CITY OF WEST LAKE HILLS, TEXAS
NOTICE OF BOARD OF ADJUSTMENT (BOA) REGULAR MEETING
Wednesday, November 9, 2022 at 7:00 PM

4. Land Use 8 Nob Hill: Discuss and consider action on a variance to allow a second driveway access (Section 22.03.175(e)(2) of the West Lake Hills Code). Applicant Tom Walters.

City of West Lake Hills Board of Adjustment

304 Bent Tree Court: Discuss and consider action on a Special Use Permit for a pool cabana (Section 38.03.032(c)(1) of the West Lake Hills Code). Applicants J. and Kimberlee Silva.

Requested Variance Site Plan 01
1"=10'-0"

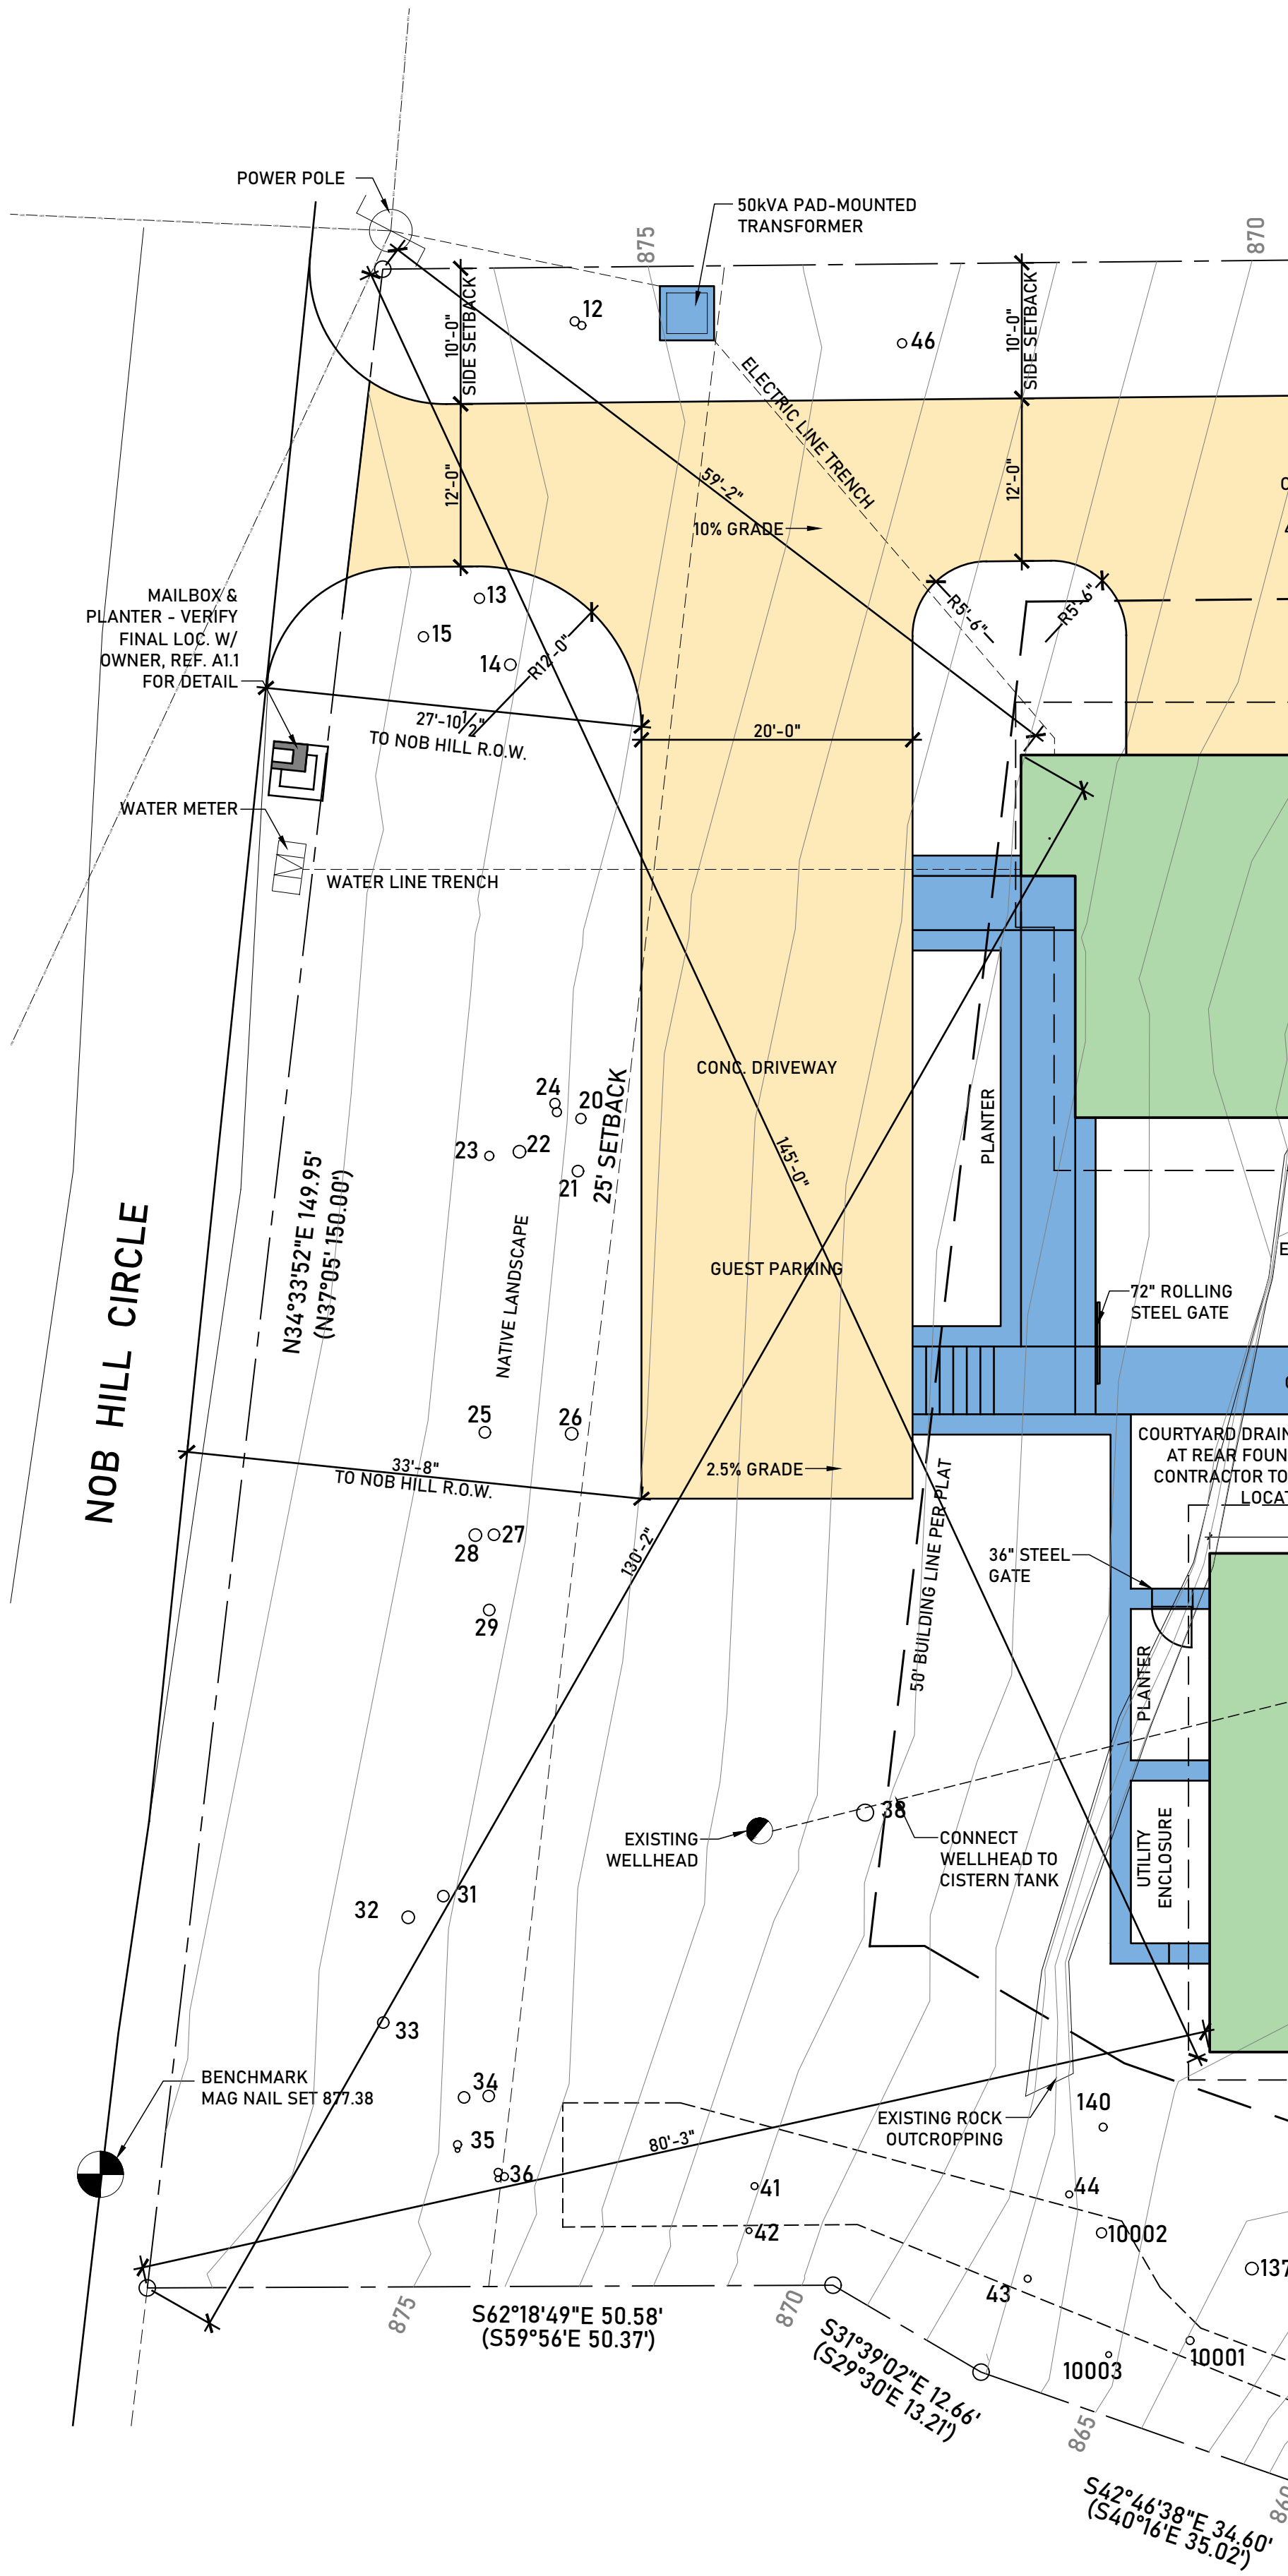
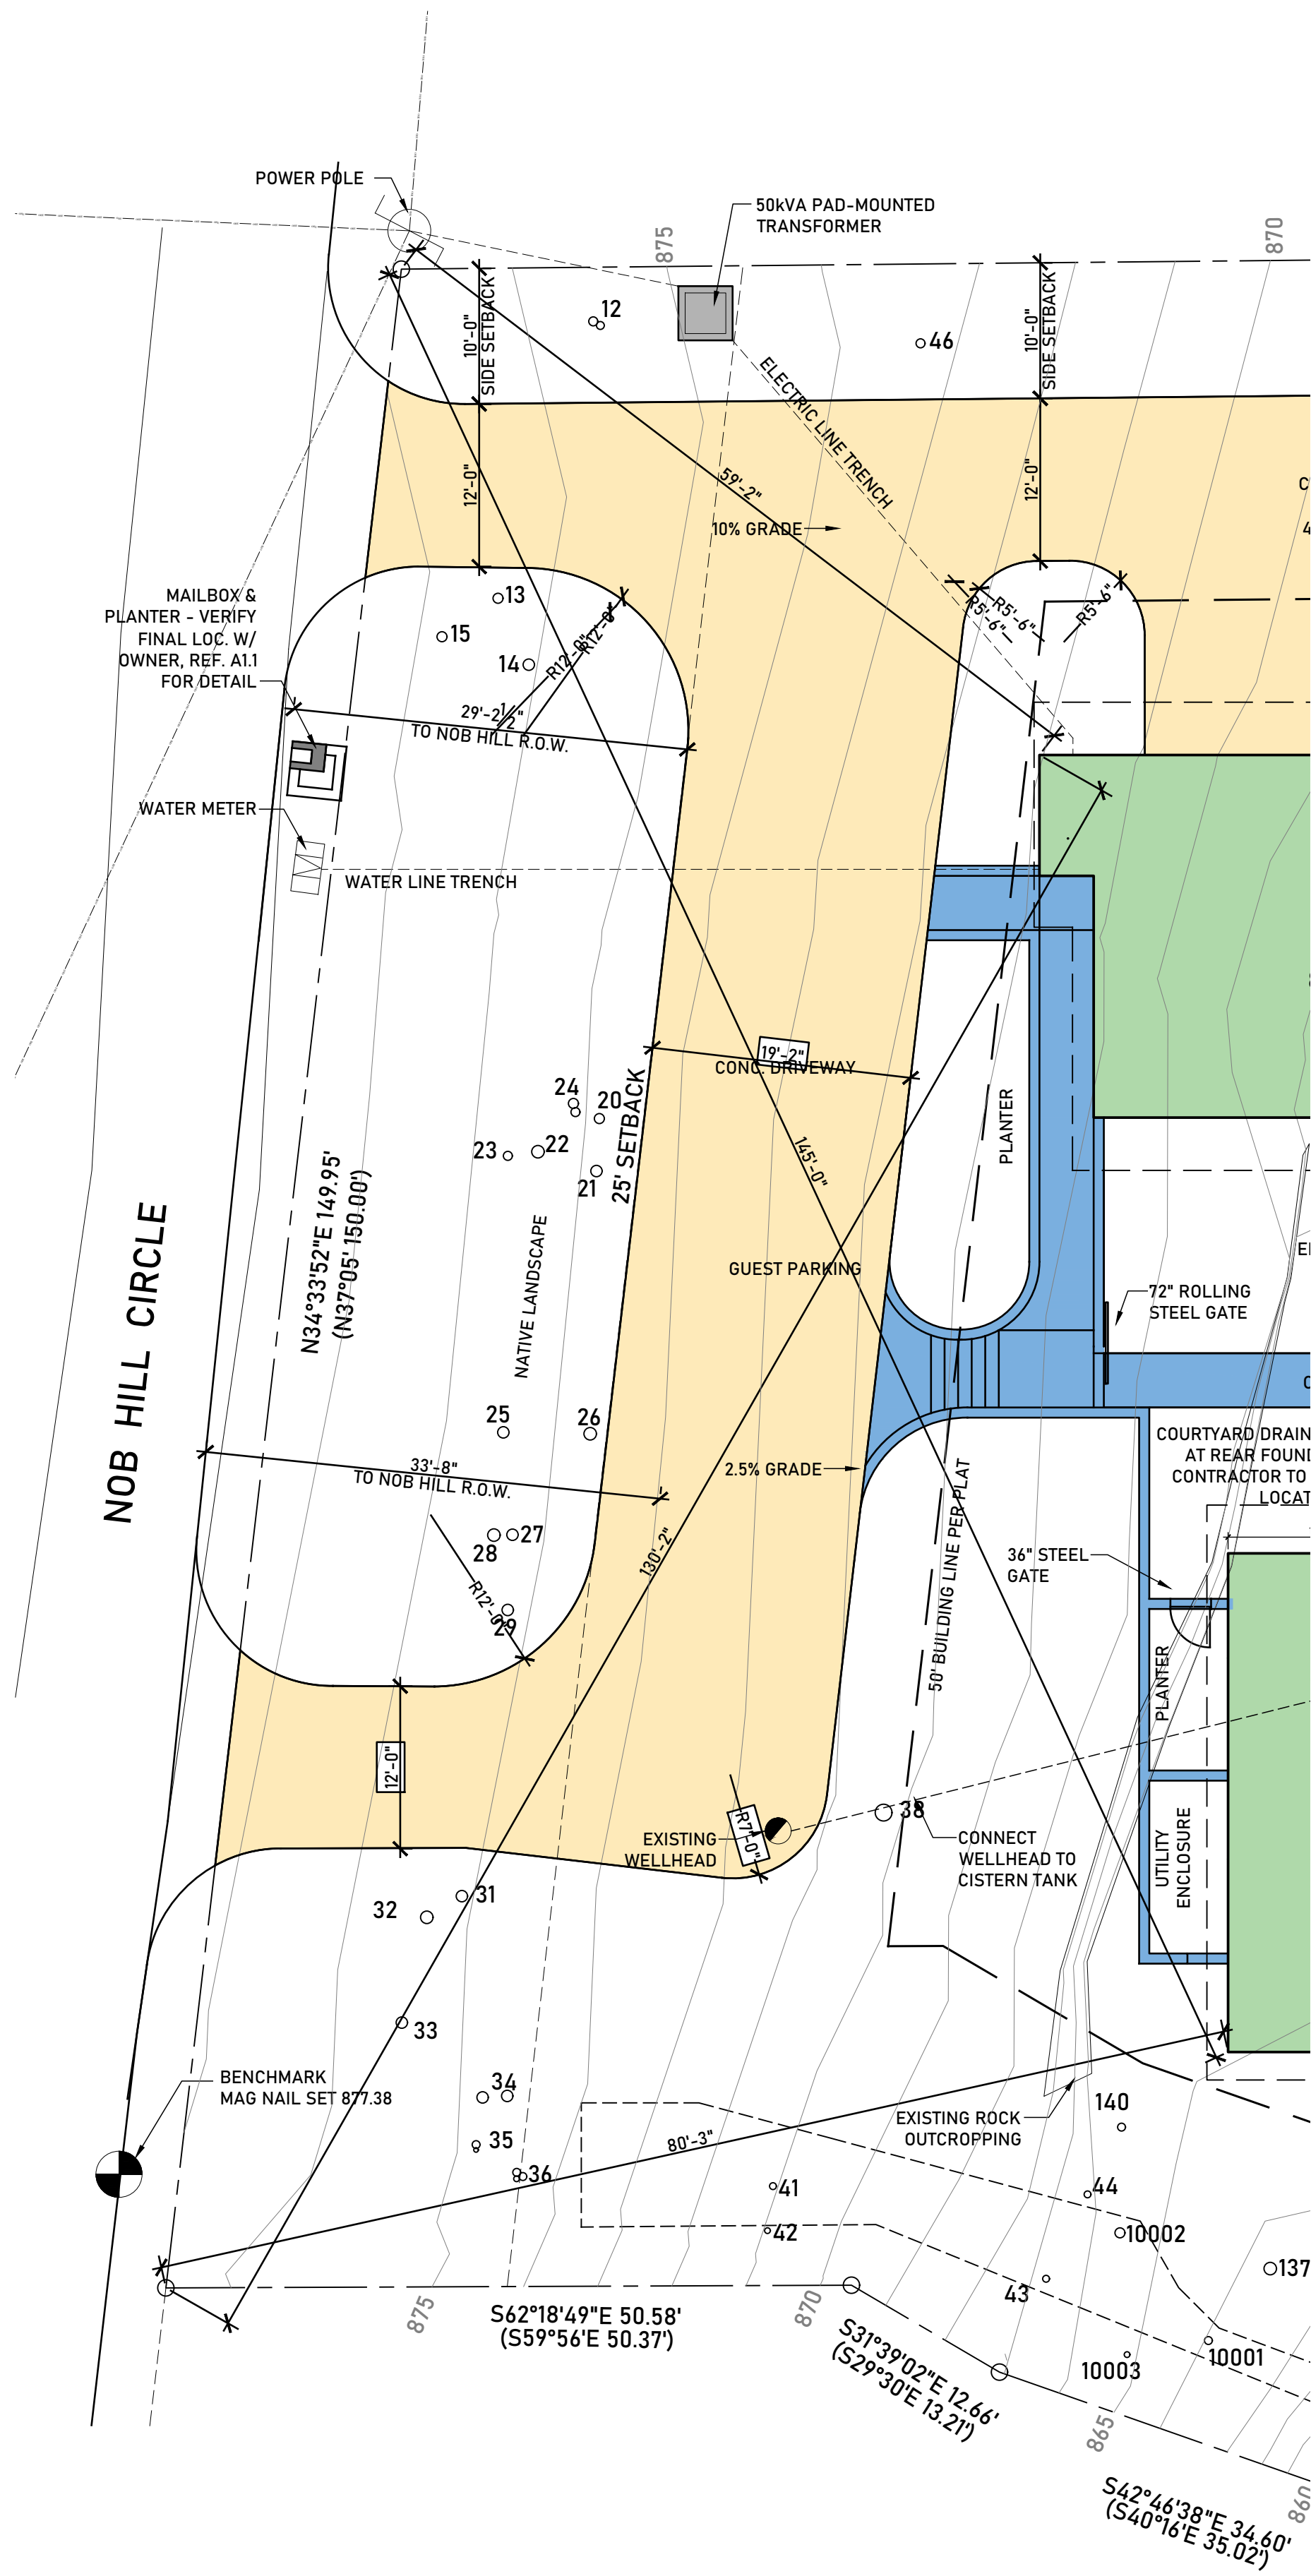
Staff recommends denial of the variances as proposed. While there is no street parking on Nob Hill, there appears to be enough parking for about 10-12 cars on site per the approved plans.

There is currently a single-family residence under construction on the lot with an active building permit. The applicant is requesting a variance to add a second curb cut to the lot.

The driveway plan has been redesigned from approved building permit to respect the existing terrain contours, (see included site plan), with minimal change to existing slope counter. This plan will NOT require the removal of any trees of any type.
